## THM 440-T4 DELAYED 2-3 SHIFT

Figure 1

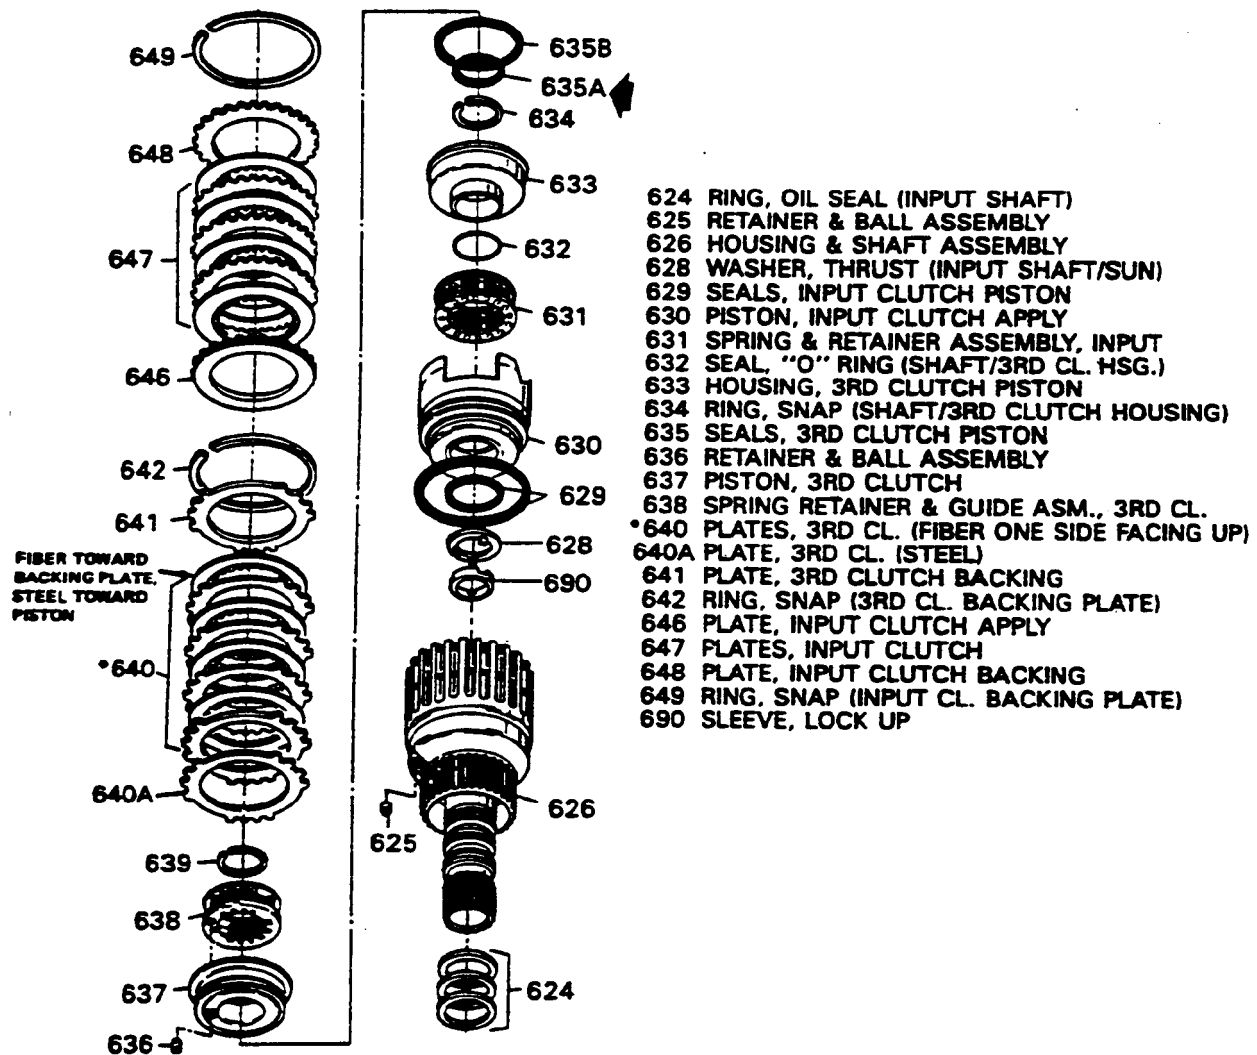
A long and/or delayed 2-3 shift on THM 440-T4 transaxle may be caused by a leaking 3rd clutch inner seal (Figure 1, Item 635A). A new, thicker seal is used in production and available for service replacement. The new seal can be recognized by a small group of hash marks on the inside diameter of the seal.
